## PLANNING DIVISION STAFF REPORT

**Project Address:** 740 University Avenue  
**Application Type:** Conditional Use  
**Legistar File ID #** [36620](#)  
**Prepared By:** Timothy M. Parks, Planning Division  
Report includes comments from other City agencies, as noted.

**Requested Action:** Approval of a conditional use to allow construction of a music performance facility at 740 University Avenue on the University of Wisconsin–Madison campus.

METRO EXHIBIT

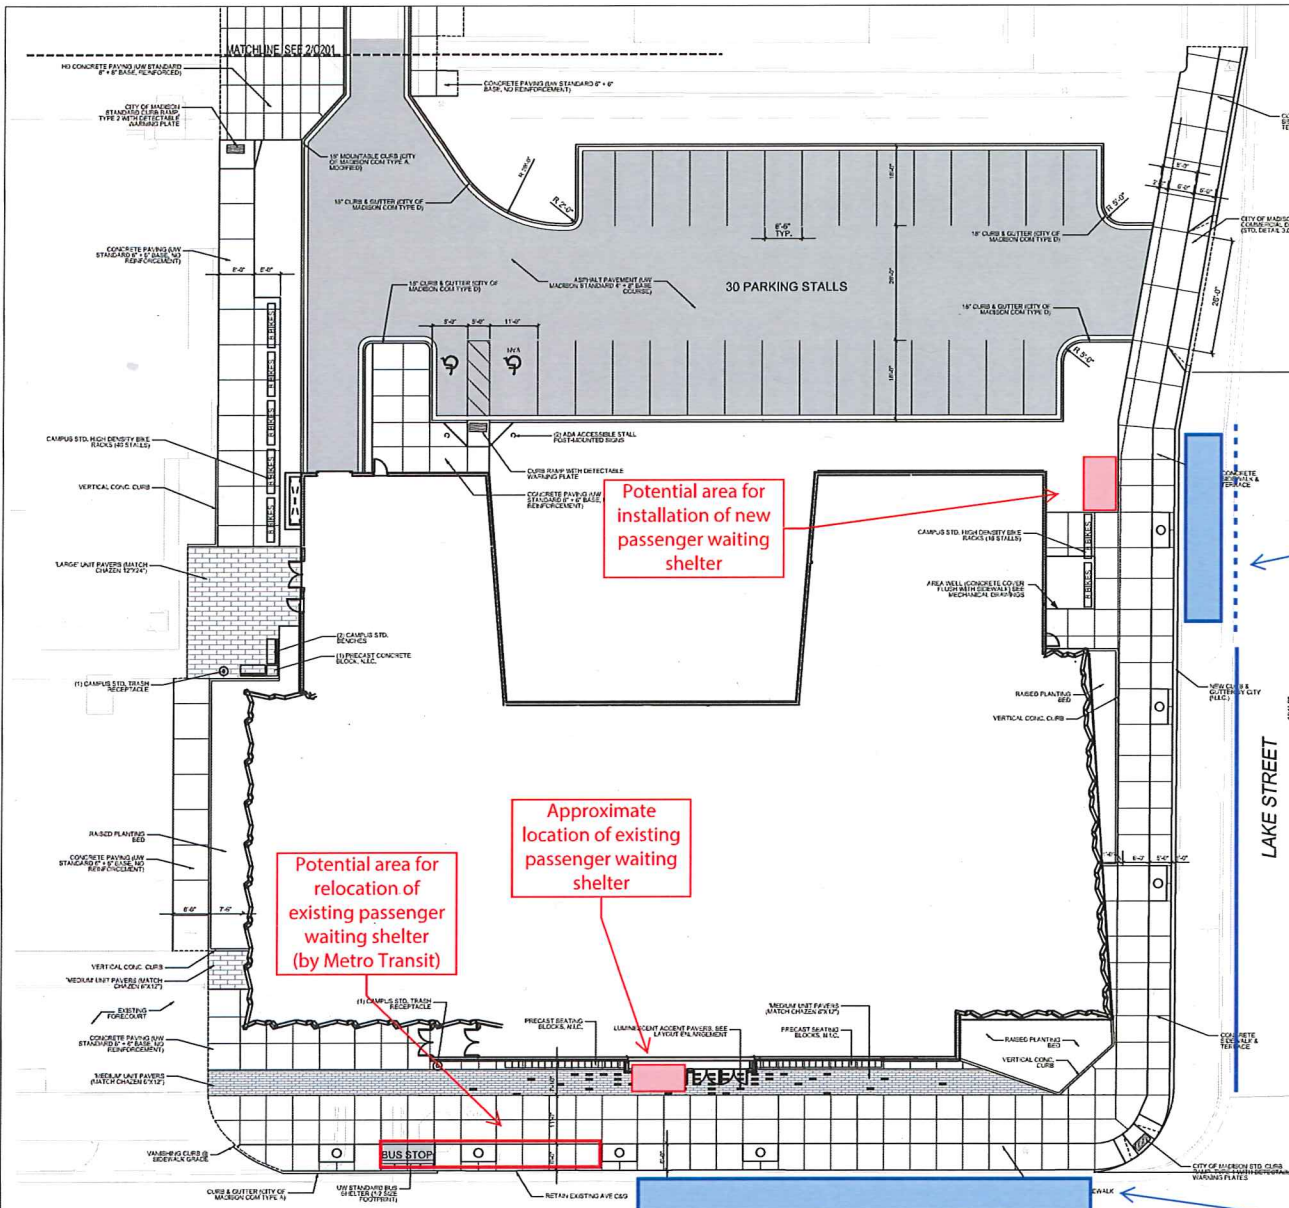
47. The applicant shall coordinate with Metro Transit staff the removal and relocation of the existing passenger waiting shelter on the north side of University Avenue, west of N. Lake Street, prior to construction.

48. The applicant shall protect the relocated passenger waiting shelter and existing curbside bus loading zone and sidewalk pedestrian access to transit vehicles during construction. Pedestrian access must be maintained along the entire block face of University Avenue, between N. Lake Street and East Campus Mall, and must comply with standards set out by the Americans with Disabilities Act.

49. The applicant shall install and coordinate the maintenance for a new passenger waiting shelter with seating amenity on the west side of N. Lake Street, north of University Avenue. The bus shelter should be installed a sufficient distance north of the intersection such that a stopped bus could depart the stop and proceed into the center through lane crossing University Avenue on southbound Lake Street. The applicant shall include the location of these transit amenities on the final documents filed with their permit application so that Metro Transit may review and approve the design.

50. The applicant might consider additional transit amenities on the property adjacent these bus stop zones, such as a trash receptacles or added benches, in finalizing their landscape plan.
